Review Comments on:
ALERT2 AirLink Protocol Specification
Timothy J. Salo^{1,2}
January 19, 2010

This document contains the author's review comments for the *ALERT2 AirLink Protocol Specification*, Version 1.0, dated May 2010, published by the National Hydrologic Warning Council (NHWC). The primary intent of these comments is twofold: to improve the quality of the specification and to highlight specific technical issues that may warrant additional consideration

Figure 1. Reviewer's View of AirLink System Components

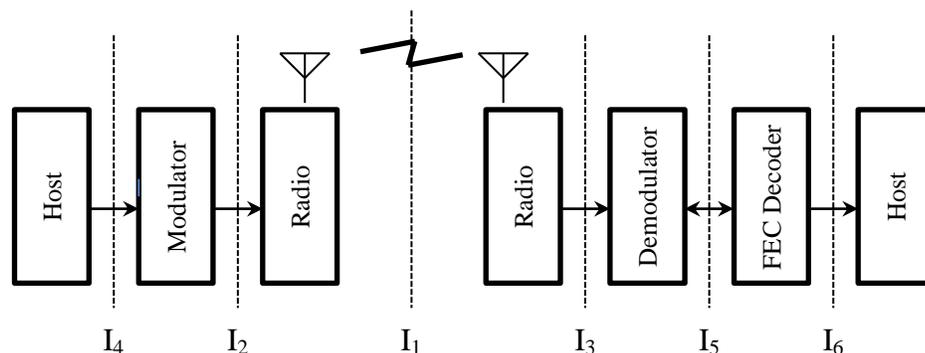
This reviewer’s best guess of the system being described is shown in Figure 1. The specification appears to describe, or in some cases assume, as many as six interfaces.

- I_1 is the AirLink on-the-air protocol, the focus of this specification.
- I_2 and I_3 are physically the audio input and output, respectively, for a voice-grade radio. The AirLink protocol imposes some requirements on these interfaces.

- I_4 is the format of AirLink frames that are transferred across a serial link between a host (e.g., a personal computer) and an AirLink modulator. It appears that neither the format of the AirLink frames nor the requirements of the serial interface are specified.

- I_5 is the bidirectional interface between the AirLink demodulator and the forward error correction (FEC) decoder. The specification of this interface appears to be incomplete. Furthermore, this interface appears to reflect a particular implementation strategy, an issue that is discussed in more detail below.

- I_6 is the interface that passes received AirLink frames to a host. The specification is not clear whether this is a physical interface or a software interface.

I recommend that the AirLink specification contains a system-level overview that clearly describes and delineates the subsystems and interfaces that are part of an AirLink system.

It is important that the boundaries of an AirLink device be clearly specified. For example, the specification should be clear whether, for example, a conformant AirLink device must implement I_5 , the interface between the AirLink demodulator and the AirLink FEC decoder. Requiring conformant devices to implement I_5 may, for example, discourage a vendor from combining a demodulator and the FEC decoding functionality into a single device. On the other hand, customers would undoubtedly benefit from a single integrated device. Conversely, not specifying I_5 may reduce interoperability and require customers to purchase a demodulator and a FEC decoder from the same vendor, if the demodulator and FEC decoder must be separate physical devices.

Figure 2. Suggested Hypothetical AirLink Device Architecture.

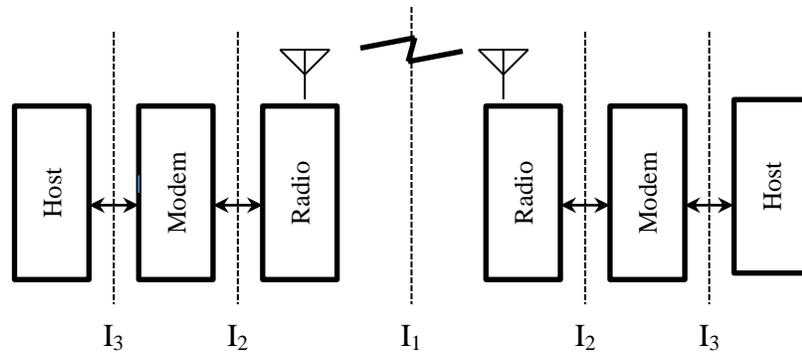
The architecture of AirLink devices described in the specification appears to be somewhat unwieldy. The simplified architecture illustrated in Figure 2 suggests that the modulator, demodulator, and FEC correction functionality should all be combined into one physical device. This would simplify the customers' acquisition, installation, and operation of AirLink devices. Furthermore, this simplified architecture would permit a broader range of implementation approaches.

I suggest that the ALERT2 Protocol Technical Working Group consider specifying the boundaries of AirLink devices such that one device must implement all AirLink functionality, including modulation, demodulation, and FEC decoding. Alternatively, if a conformant AirLink device could implement only modulation, but not demodulation, or the converse, this should be stated explicitly (since is it rather unusual).
